Ref: 20E-14-0214-TNT-351955-1

Maquarie Park Village, Section 75W, Wind Update

Stamford Property Services has engaged Vipac to provide a re-assessment of the impact to the wind environment of the current design of Stage 1 of the proposed development at 110-114 Herring Road, Macquarie Park, NSW. Vipac conducted an assessment on the original design as detailed in report 30N-12-0107-TNT-304814-4. The pedestrian wind environment adjacent to the development was found to be acceptable in the original assessment such that the walking comfort criterion was achieved in the pathways and the standing criterion was achieved in the main entrances.

Figure 1: Lower ground floor plan for the *Maquarie Park Village* development – comparison between current design and design previously assessed (Stage 1: Building A, B, D and P)

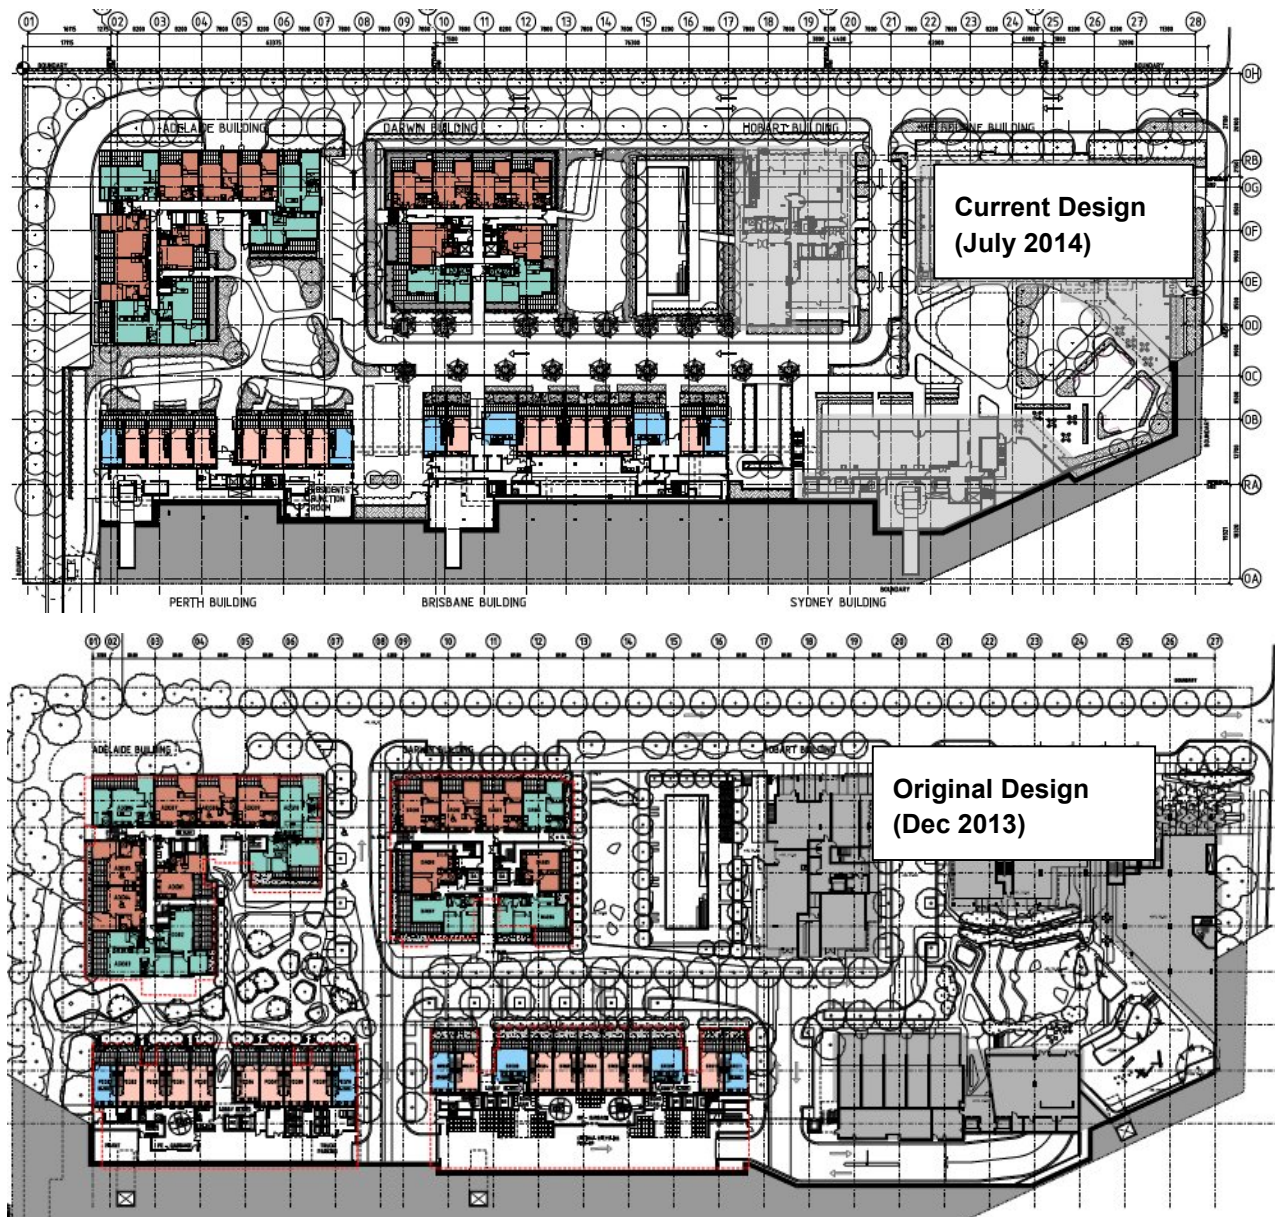
The original and current plans for the lower and upper ground floors are shown in Figure 1 and 2. Stage 1 includes four buildings, namely, Building A, B, D, and P. The comparisons for the particular elevations of the four buildings are shown in Figures 3 to 6. It can be seen that in terms of the overall building form and height, the design remains largely the same. The landscape plantings are also shown in Figures 1 and 2. Some changes can be seen from these plans. A driveway has been added on the west side of Building A and P in the updated design and the original trees adjacent to the buildings have been removed. This would result in an increase in wind levels; however, as driveways are not required to meet the walking criterion, the wind environment would still be within the acceptable safety criterion.

The east side of building A has specified some parking bays and the original trees have also been removed. This may cause some increase of the wind speed along the east foot path of the building A, however, we expect that this would still be within the walking criterion. Similar changes for the open areas between Buildings D and H can be seen. We believe that the above changes do not alter the original assessment result.

We have reviewed the current design to determine its impact on the adjacent ground level wind environment. We expect that the current design would have the similar wind environment as the original design, which achieved walking comfort in the pedestrian walkways and standing comfort in the main building entrance. Thus, we make no recommendations for the alteration of the building as proposed.
